9 MAY 91

SUBJECT: TRIM OF EXCESS ON LEAD END OF BEAM TUBE  
FOR USE ON DCA 310 ONLY.

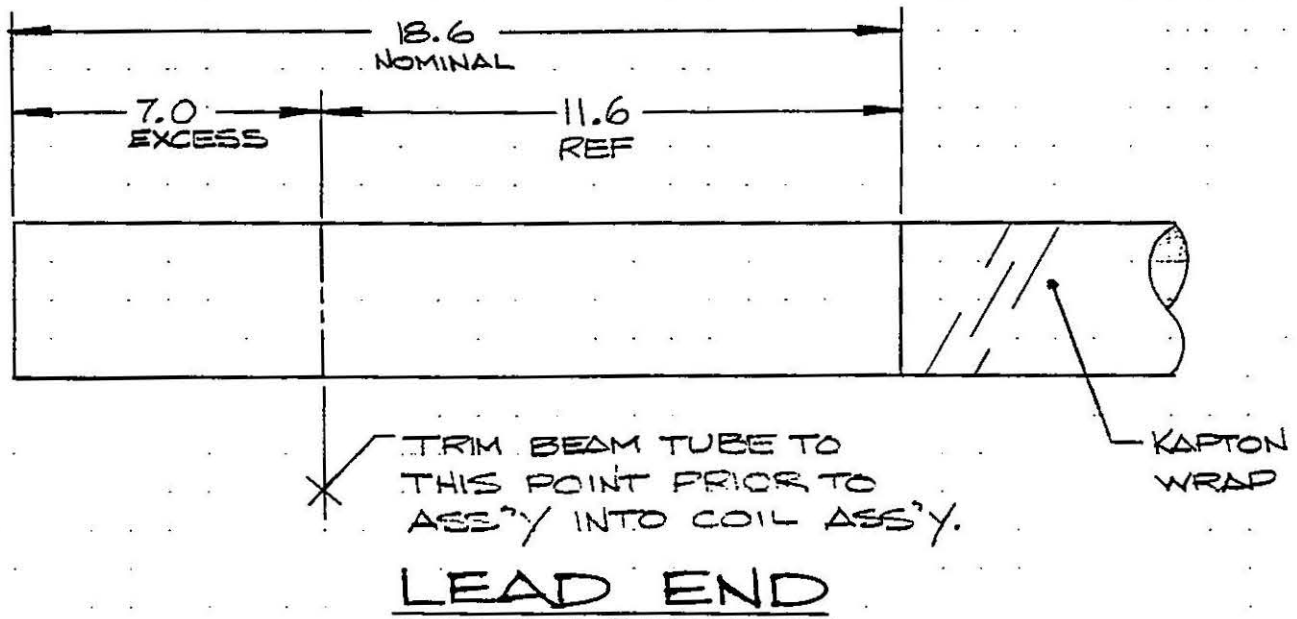
DUE TO THE LACK OF INFORMATION CONCERNING THE NECESSARY LENGTH OF THE BEAM TUBE EARLIER AND THE NEED FOR THEM, THE BEAM TUBES WERE ORDERED WITH EXCESS ON EACH END. THE FOLLOWING INFORMATION DESCRIBES THE NECESSARY TRIM ON THE LEAD END ONLY!

\* NOTE: RETURN (NON-LEAD) END TO BE TRIMMED AT A LATER ASS'Y.
